From: Froede, Carl [mailto:Froede.Carl@epa.gov]
Sent: Tuesday, June 11, 2019 12:16 PM
To: DePaoli, Susan (CONTR) <Susan.DePaoli@orem.doe.gov>; Brad Stephenson <Brad.Stephenson@tn.gov>; Beth Rowan <Beth.Rowan@tn.gov>; Osteen, Bill <Osteen.Bill@epa.gov>
Cc: Sager, Joy Lynn <Joy.Sager@orem.doe.gov>; Pfeffer, Julie (JP2) <Julie.Pfeffer@ettp.doe.gov>; Michael D. Higgins <Michael.D.Higgins@tn.gov>
Subject: TM-2 -- Response to EPA/TDEC comments...
Importance: High

Document Number: DOE/OR/01-2785 – pre-published version	Document Title: <i>Technical Memorandum #1, Environmental Management Disposal Facility Phase 1 Field Sampling Results Oak Ridge, Tennessee</i>		
Organization/Project: EPA/EMDF	Comment Due Date: N/A

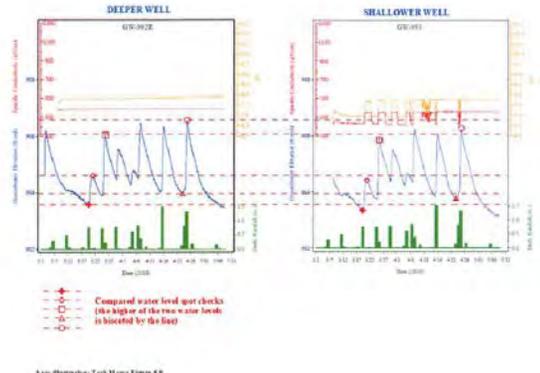
Comment No.	Reviewer Initials	Section, Page, Paragraph	Comment/Suggested Change/Rationale	Resolution	Reviewer Concurrence
			<p>deeper of the GW- 992R/GW-993 wells had a higher water level than the shallower well (see Figure 1 below) while at GW- 982 and GW-983, the shallower well typically had the higher water level (see Figure 2 below). These water-level relationships are consistent with the overall conceptual model of groundwater flow (downward vertical gradient component in upslope recharge areas; upward vertical component in downgradient discharge areas). The conclusions reached should be better explained within the context of the seasonality of changing water levels in these wells. As presented the conclusions are misleading. Correct to reflect the varying nature of the wells by adding another column (or two) indicating a different time and a different hydraulic gradient.</p> <p style="text-align: center;">Figure 1. Spot Check Comparisons of GW-992R and GW-993 Water Levels</p>  <p style="text-align: center;">See Attachment: Tech Memo Figure 59</p>
